ARABIAN ACRES METROPOLITAN DISTRICT
DISTRIBUTION SYSTEM IMPROVEMENT PROJECT
FINAL ENGINEERING DRAWINGS
MARCH 2020

PROJECT: DISTRIBUTION SYSTEM FINAL DESIGN
PROJECT NUMBER: 1289
CLIENT: ARABIAN ACRES METROPOLITAN DISTRICT
LOCATION: UNINCORPORATED TELLER COUNTY, COLORADO
DESIGNED BY: MIKE GROSELLE, P.E.
CHECKED BY: ADAM SOMMERS, P.E.
FILE PRINTED ON: 3/27/2020 2:28:32 PM
COPYRIGHT: AQUAWORKS DBO, INC.
DRAWING SIZE: 22" X 34"

RAW WATERLINE I - II
STA 14+00 TO END
RAW WATERLINE II
STA 1+00 TO END

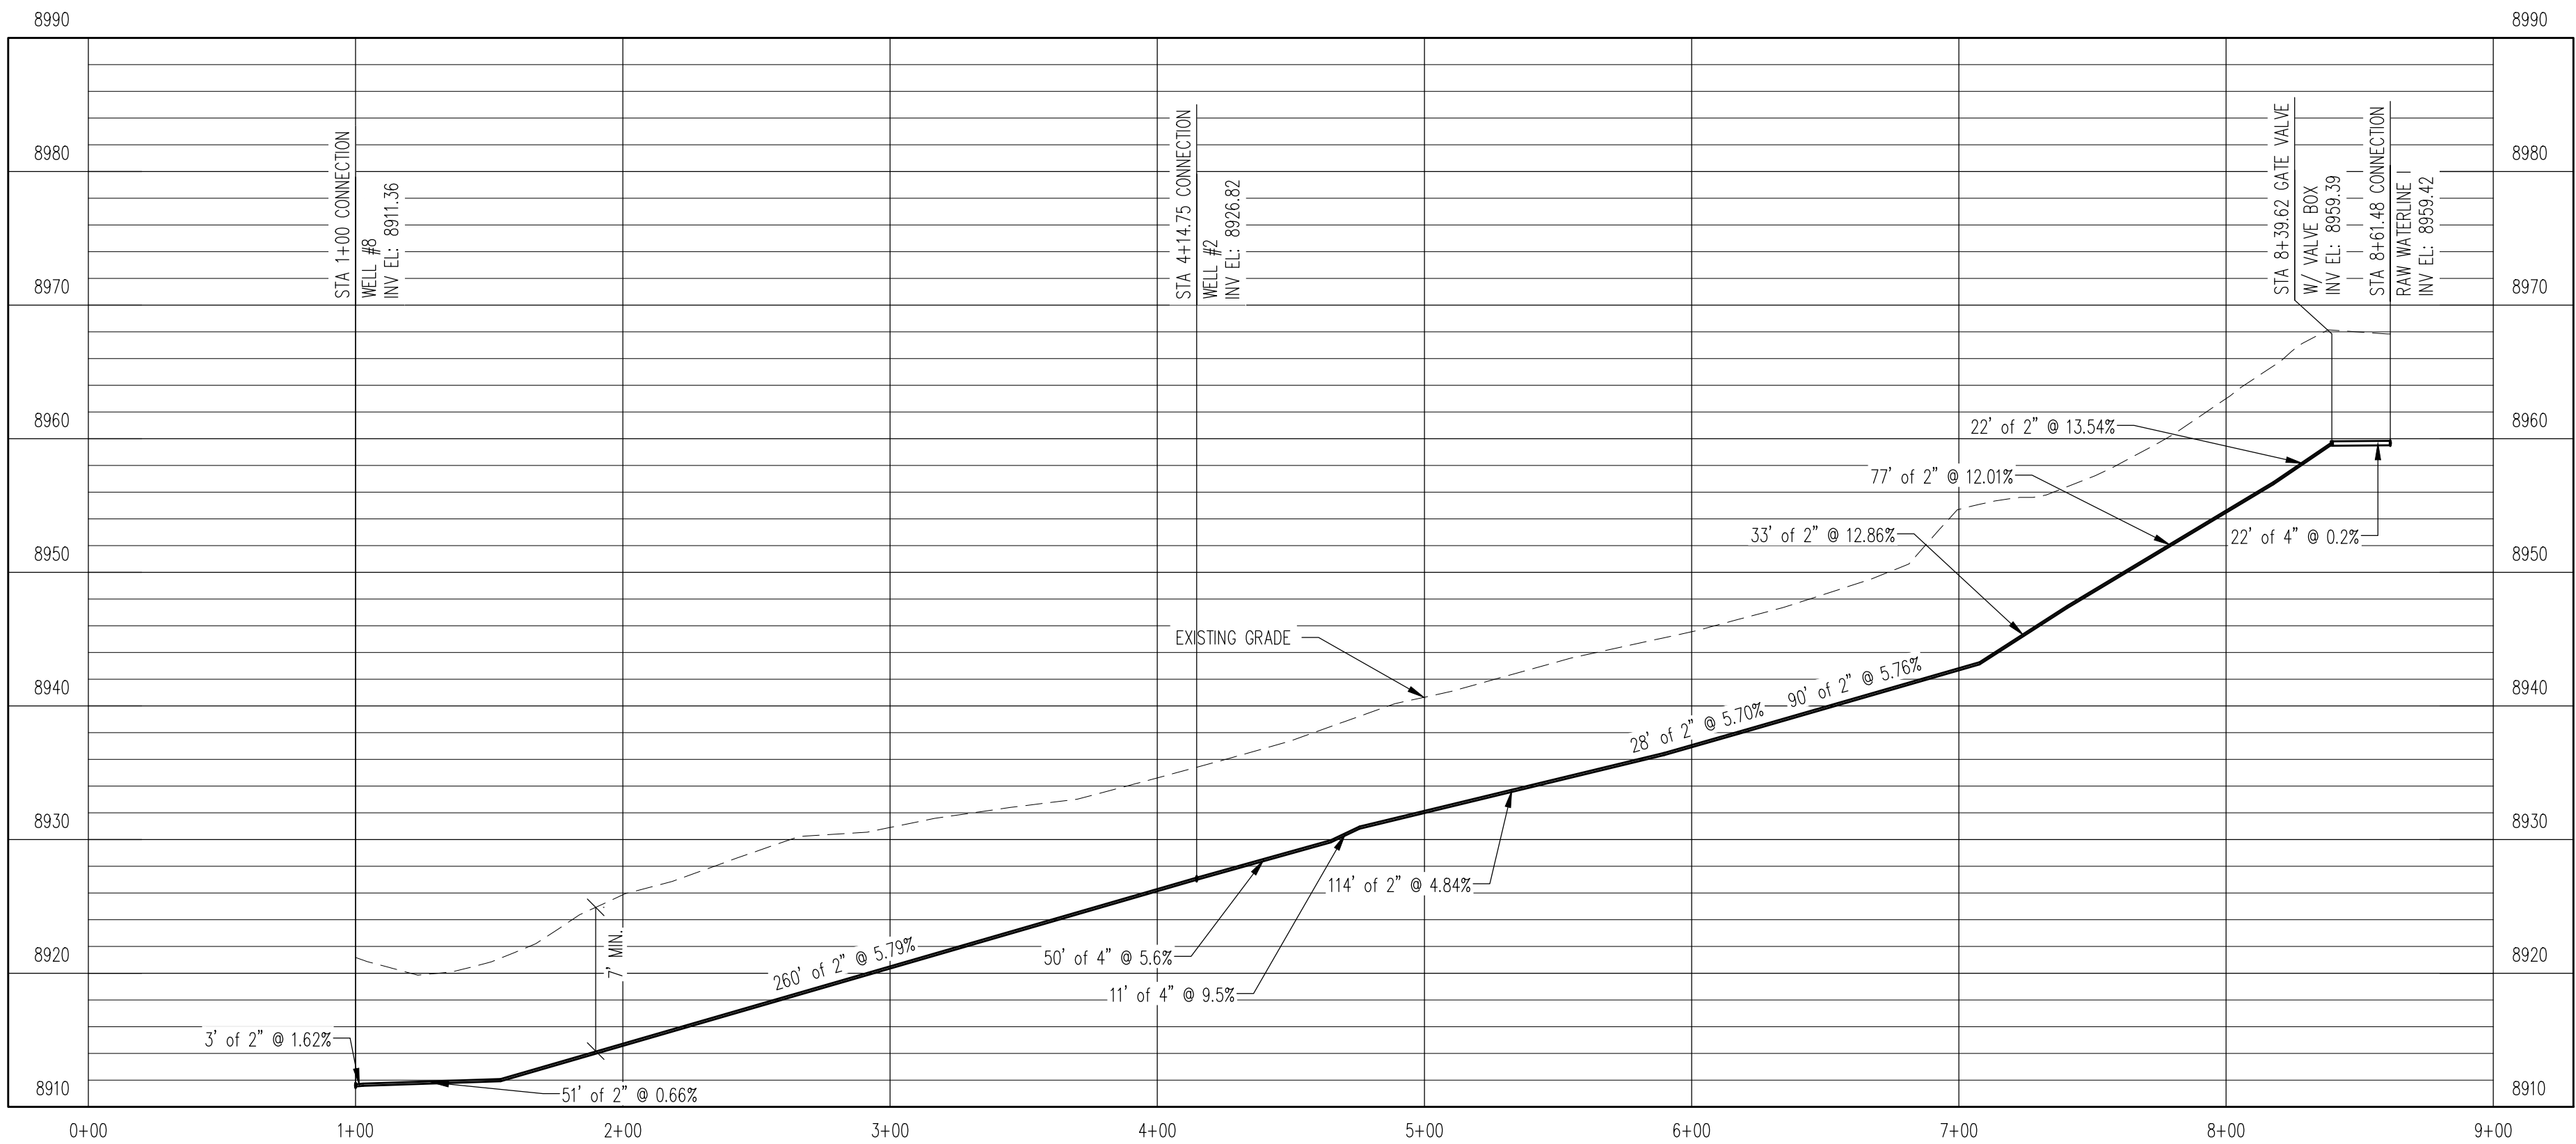
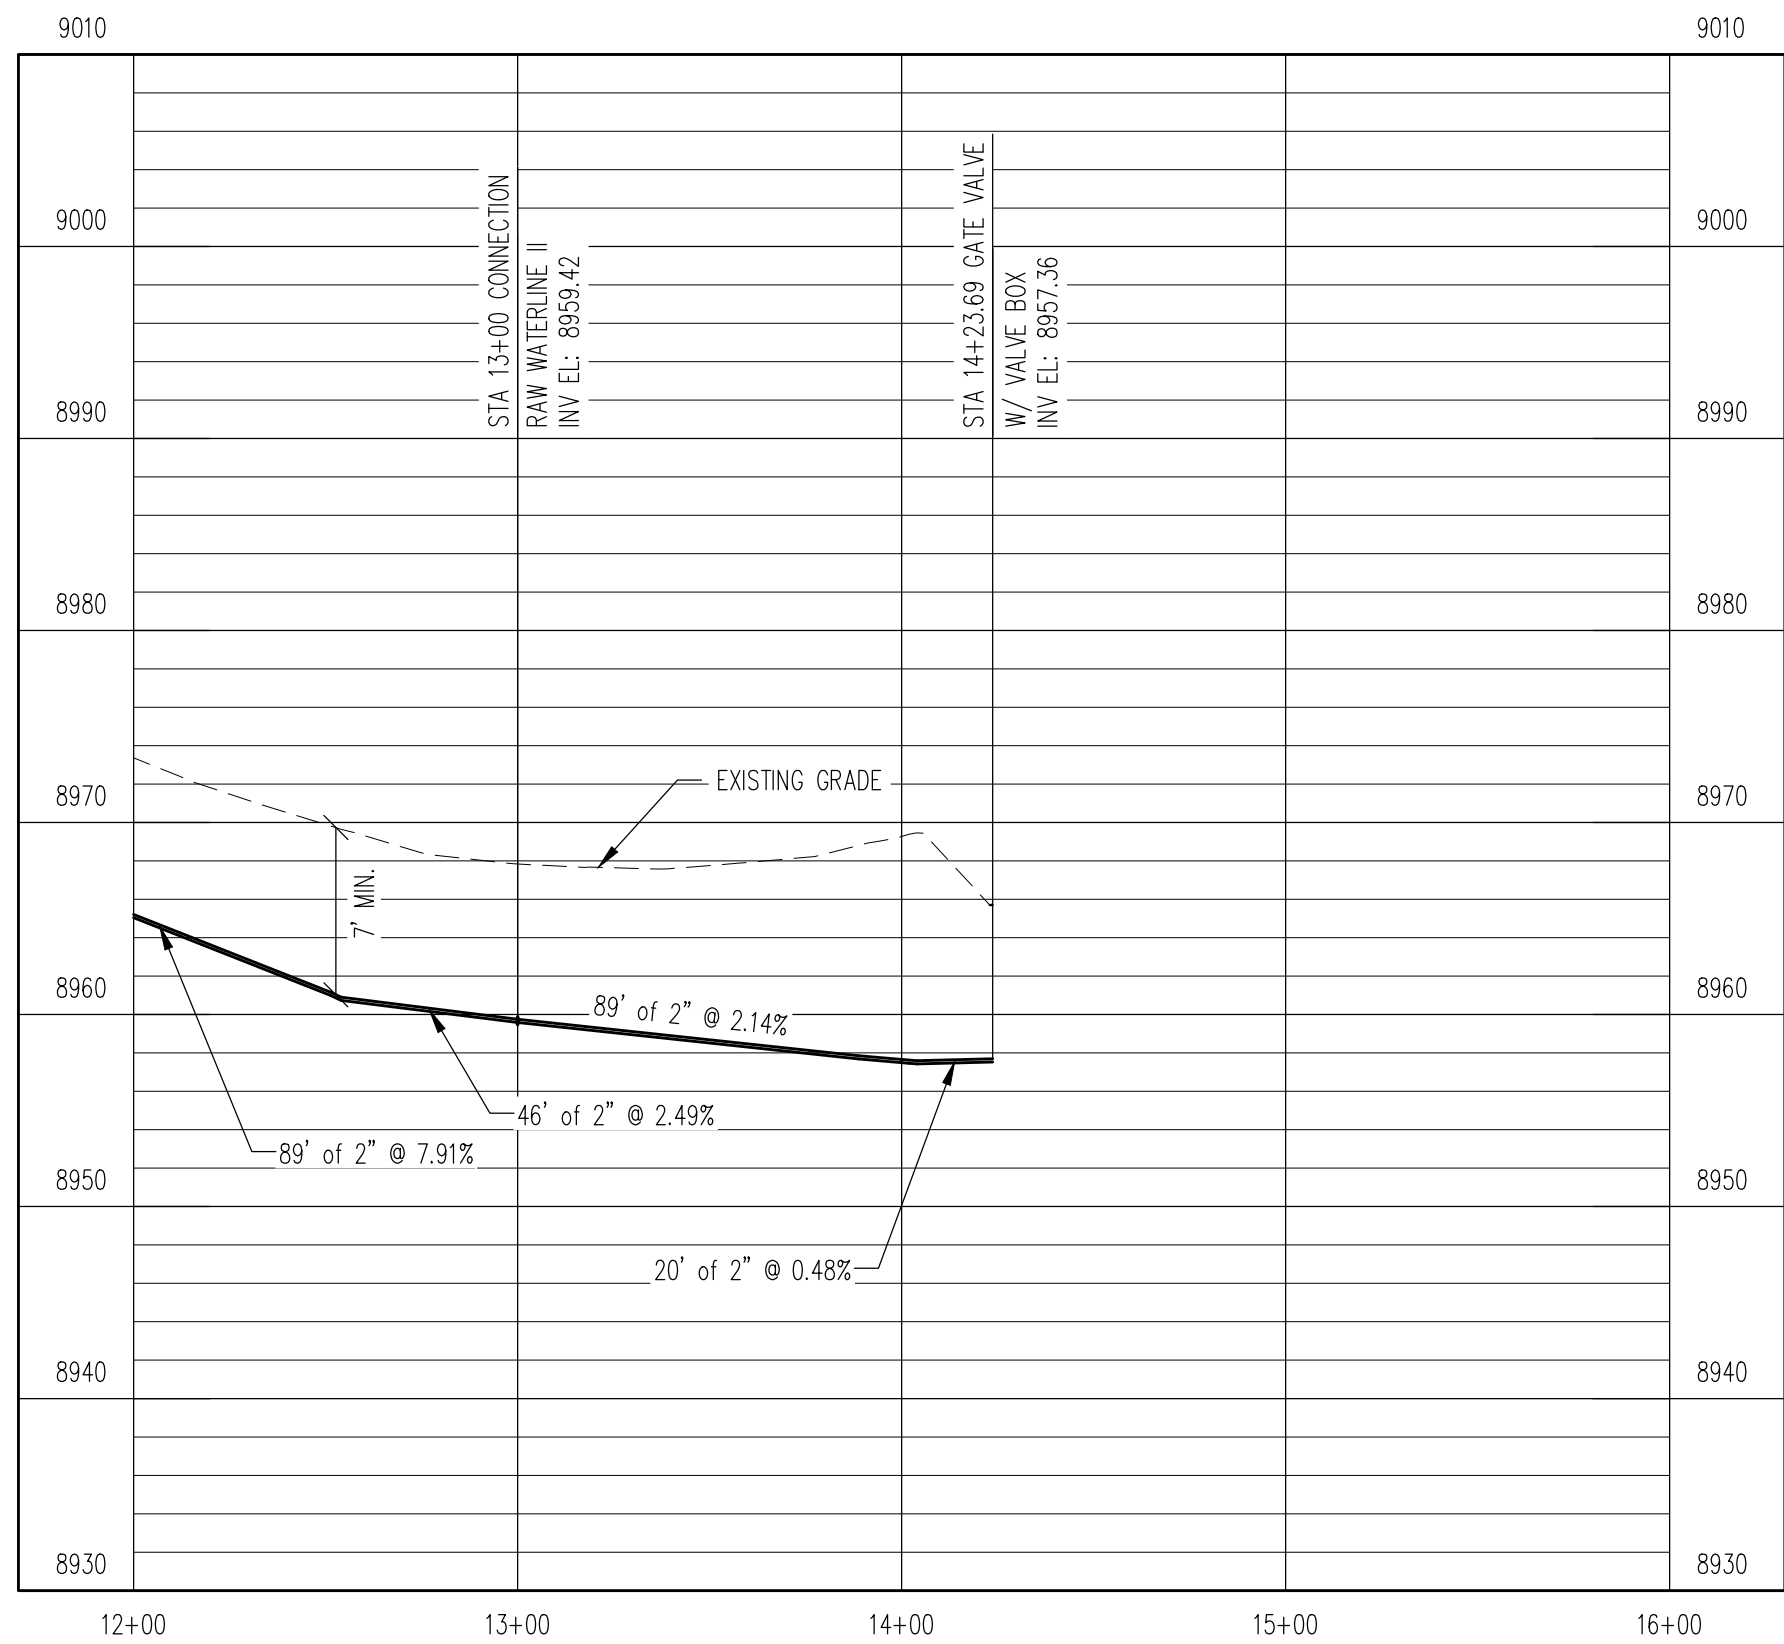
4" gate valve installed
7/8. Pipe completed
to this point. Gate
valve needs to be
opened. No significant
rock noted.

Meter pit was
reconnected
to new line.
Should be a
change order
of 3 guys for
an hour or so

Moving to this area was 2
hours of mobilization and
demobilization of the entire
crew. About 8 hours of delays
for 2-3 workers and a mini
excavator.
